Access Compliance Report

Public Rights-of-Way

Intersection ID: 11266	Main Street: AXAR_RD	Cross Street: MULBERRY_CHURCH_RD	Location: NE
ADA ID: FB39D1F71EC1	Ramp Type: Perp	Initial Pass/Fail: Fail	Overall Compliance: No
Severity Score: 21.25			
Codes/Mitigation Info/Possible Solution		Field Measurements/Component Compliance

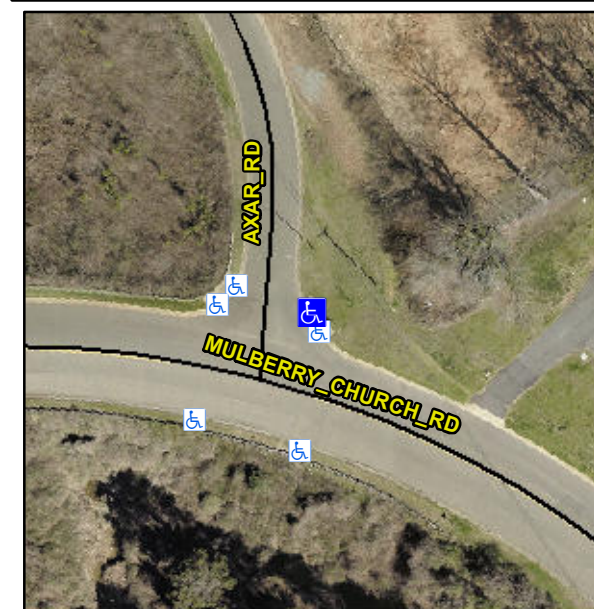
Not Found, R304.5.1, R304.2.2

Compliance	Description	Data	Compliance	Description	Data
N/A	Ramp Length (in)	67.0	No	Ramp Slope (%)	8.5
No	Ramp Width (in)	36.0	Yes	Ramp XSlope (%)	1.9
N/A	Flare Type LT	N/A	N/A	Flare Type RT	N/A
N/A	Flare Slope LT (%)	N/A	N/A	Flare Slope RT (%)	N/A
N/A	Flare Traversable LT?	N/A	N/A	Flare Traversable RT?	N/A
N/A	Landing Length (in)	N/A	N/A	DWS Provided?	N/A
N/A	Landing Width (in)	N/A	N/A	DWS Contrast?	N/A
N/A	Landing Slope (%)	N/A	N/A	DWS Length (in)	N/A
N/A	Landing X Slope (%)	N/A	N/A	DWS Full Width?	N/A
N/A	Landing Curb? (Y/N)	N/A	N/A	DWS Offset (in)	N/A
N/A	Shared Landing?	N/A			
N/A	Gutter Ponding?	N/A	N/A	Gutter Slope (%)	N/A
N/A	Gutter Lip Ht (in)	N/A	N/A	Gutter X Slope (%)	N/A
N/A	Painted X Walk1?	No	N/A	Painted X Walk2?	N/A
	X Walk 1 Direction	To W		X Walk 2 Direction	N/A
N/A	X Walk 1 Width (in)	N/A	N/A	X Walk 2 Width (in)	N/A
	X Walk 1 Slope (%)	3.3		X Walk 2 Slope (%)	N/A
	X Walk 1 X Slope (%)	1.0		X Walk 2 X Slope (%)	N/A

Remove & Replace Entire Ramp.
